Application for Works Approval

Works Approval Number	W3016/2025/1
Applicant	Wallcliffe House Pty Ltd
ACN	611 627 340
Application number	APP-0029203
File number	INS-0003016
Premises	Wallcliffe House Wastewater Treatment Plant Lot 101 Wallcliffe Road MARGARET RIVER WA 6285 Legal description - Part of Lot 101 on Deposited Plan 49026 As defined by the premises map attached to the issued works approval
Date of report	19 December 2025
Decision	Works approval granted

Figure 2: Location of WWTP and Leach Drains (Infiltration Structures)

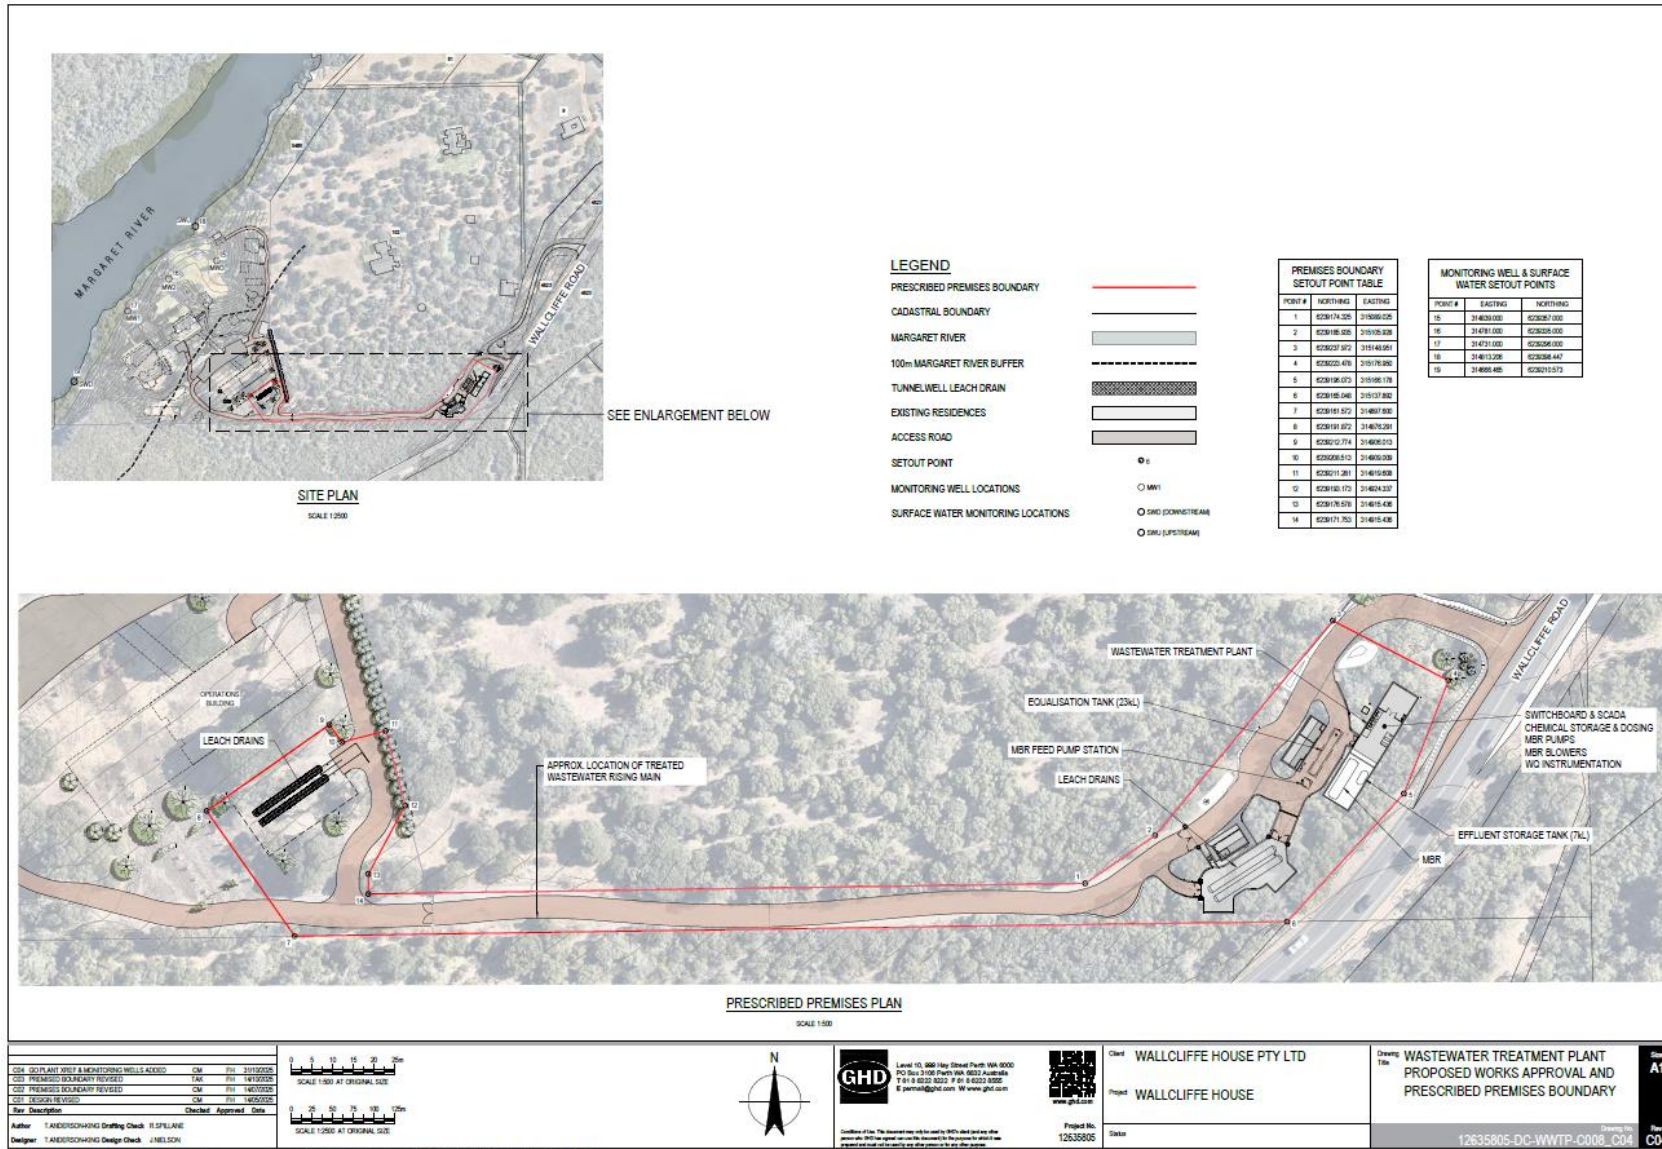
Condition 10, Table 2	Note type 3 (g) is 3(b)	This has been noted and corrected by the Delegated Officer.
Condition 11	<p>Reword to <i>"Leach Drains as installed within prescribed premises boundary (Figure 1)"</i></p> <p>Figure 1 has been updated</p>	Figure 1 has been updated. The original condition wording still applies.
Condition 14	There is a typo. The condition should refer to Table 5 and not Table 4.	This has been noted and corrected by the Delegated Officer.
